## DEVIATION REQUEST AND DECISION FORM

### Deviation No. 1 (Revised 2-29-20)

### PCD File No. PPR-0199

Project Name :	Monument Academy Charter School
Schedule No.(s) :	6100000245
Legal Description :	THAT PART OF NW4 LY ELY OF E R/W LN OF HWY 83 EX RD, E S 200 FT OF SE4NW4, EX 0.49 A TO AMERICAN TEL + TEL SEC 15-11-66

Figure 2

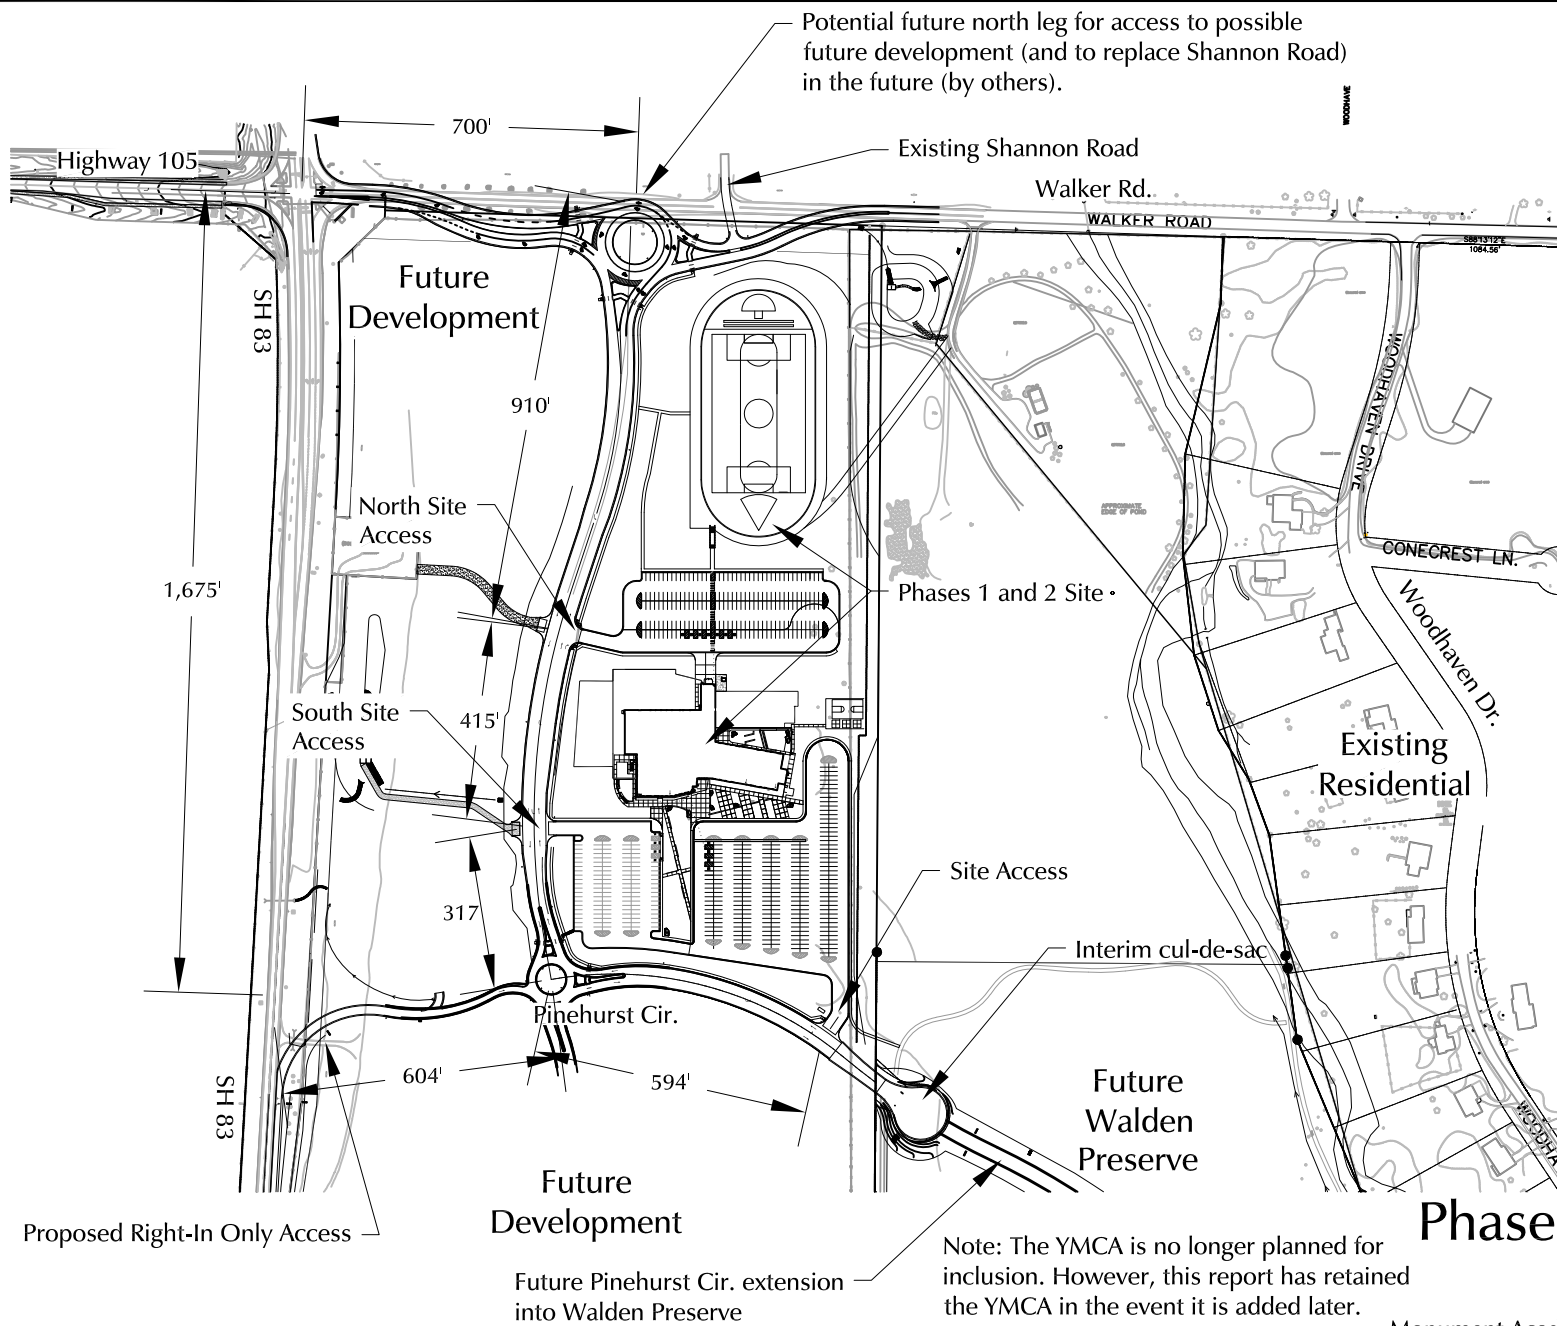
The deviation is for a new public street intersection on Walker Road. The intersecting street would be the proposed new north-south Urban Non-Residential Collector, Jane Lundeen Drive, just east of State Highway 83. The ECM-prescribed intersection spacing along a Rural Minor Arterial is one-quarter mile. This deviation request is to allow for an intersection to Walker Road 700 feet east of SH 83 and 185 west of Shannon Drive. The attached exhibit (copy of Figure 2 from the Monument Academy Traffic Impact Study) shows the proposed spacing.

Based on Table 2-4, the intersection spacing to a Rural Minor Arterial is 1/4 mile (1,320 feet). The proposed intersection of Walker Road and Jane Lundeen Drive is located 700 feet east of SH 83 (620 feet short of the required spacing) and 185 feet west of Shannon Drive (1,135 feet short of the required spacing).

Figure 2  
**Phases 1 and 2  
Site Plan**

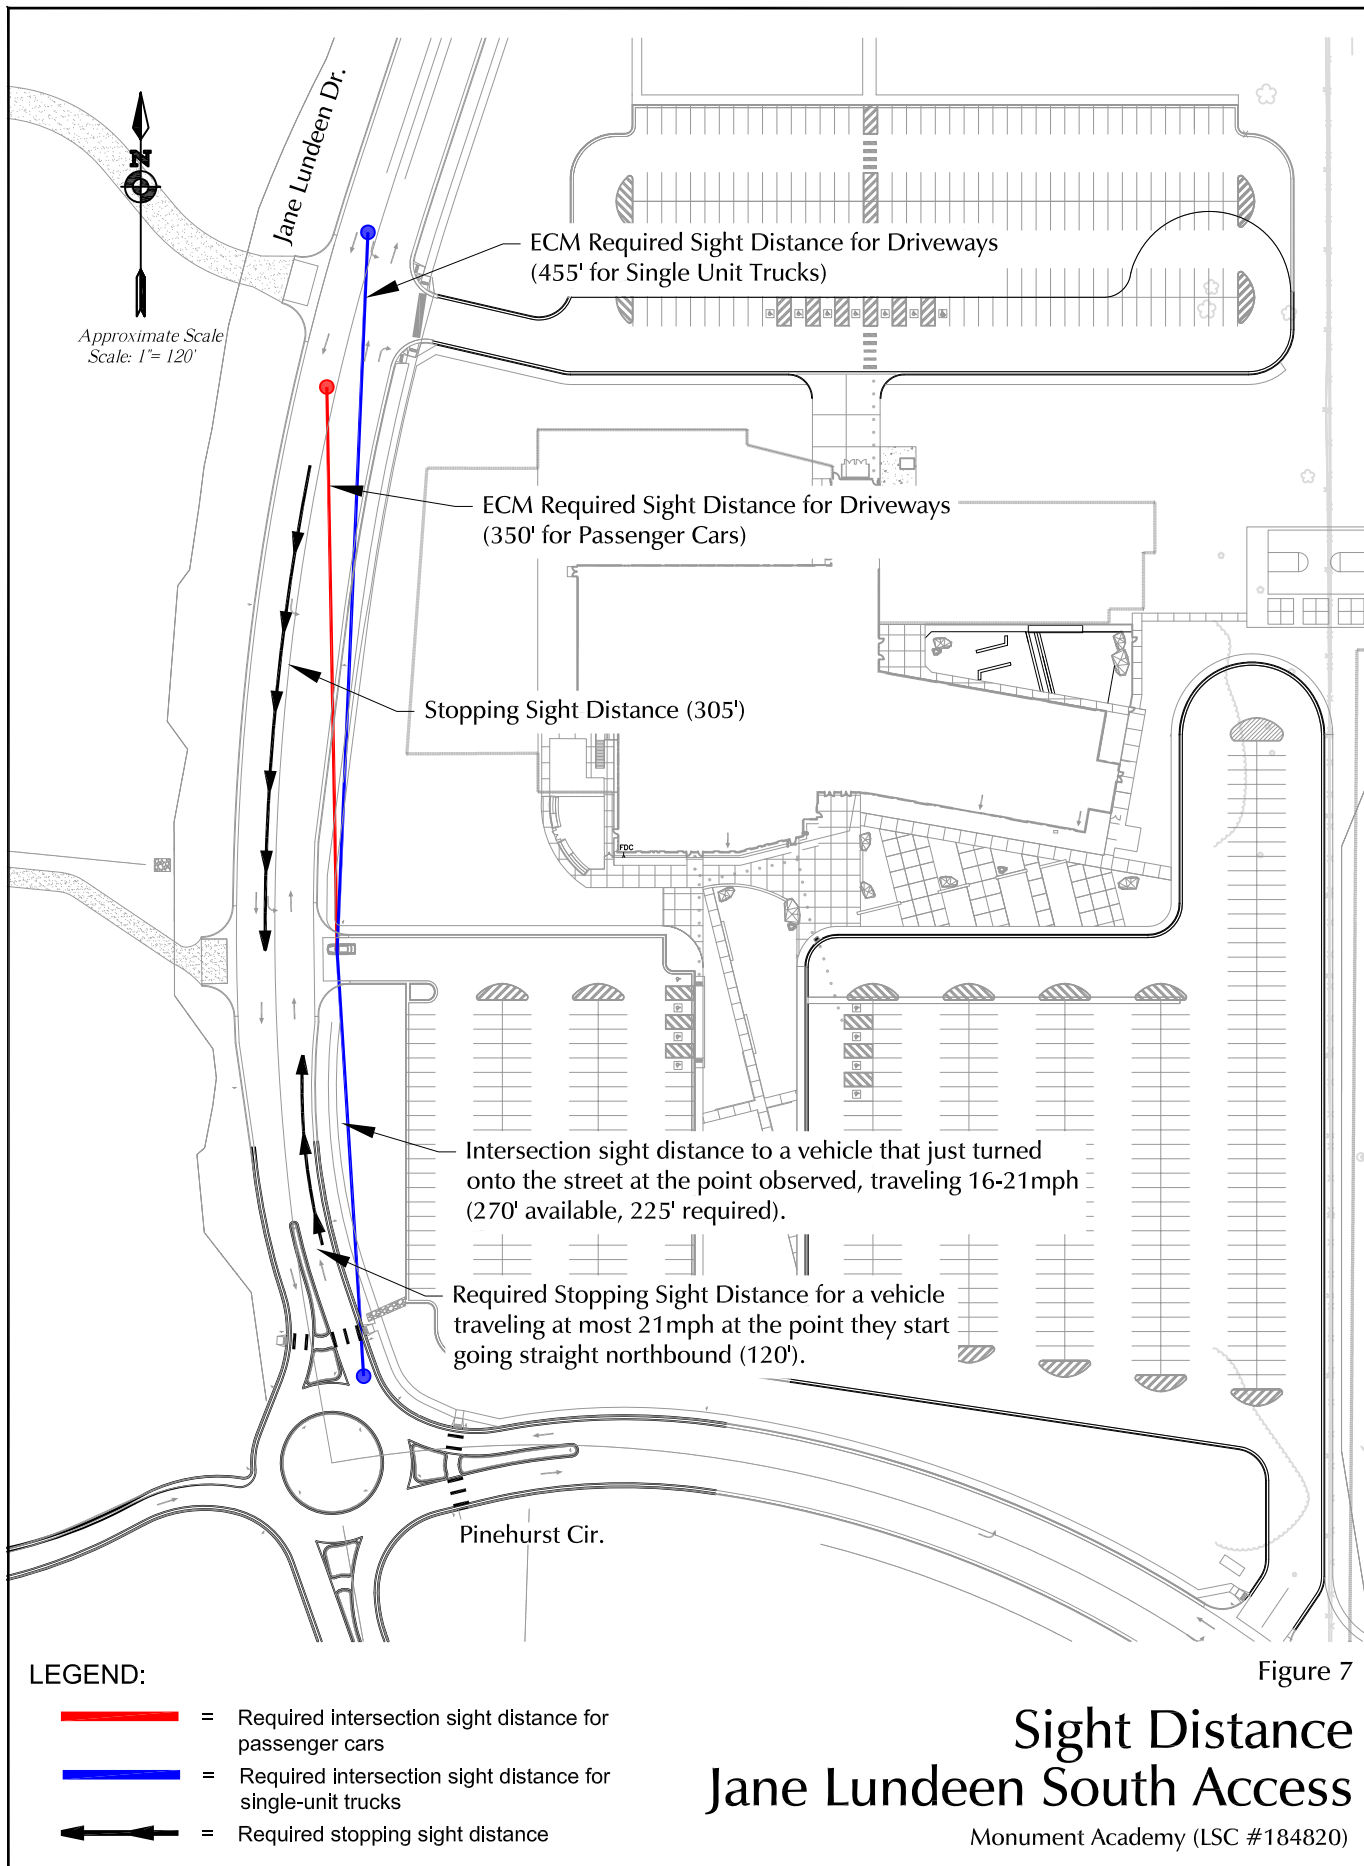
-The proposed access plan is shown on the attached Figure 2 from the TIS Report.

- The proposed school access spacing is based on meeting the criteria contained in ECM Table 2-35 Entering Sight Distance for Driveways. Based on a posted speed limit of 35 miles per hour, the required sight distance for passenger cars and pickup trucks is 350 feet and the required distance for single unit trucks is 455 feet. The deviation would allow for an access to Jane Lundeen Drive 317 feet north of Pinehurst Circle and 415 feet south of the next access point. The attached copy of Figure 2 from the Monument Academy Traffic Impact Study shows the proposed access spacing.

Comparison to ECM Standards: Based on a posted speed limit of 35 miles per hour and assuming a single unit truck as the design vehicle the required entering sight distance for access design is 455 feet. The requested south access location is 317 feet north of Pinehurst Circle and 415 feet south of the next access point to the north. This is 138 feet less than the required distance to the south and 40 feet less than the required distance to the north.
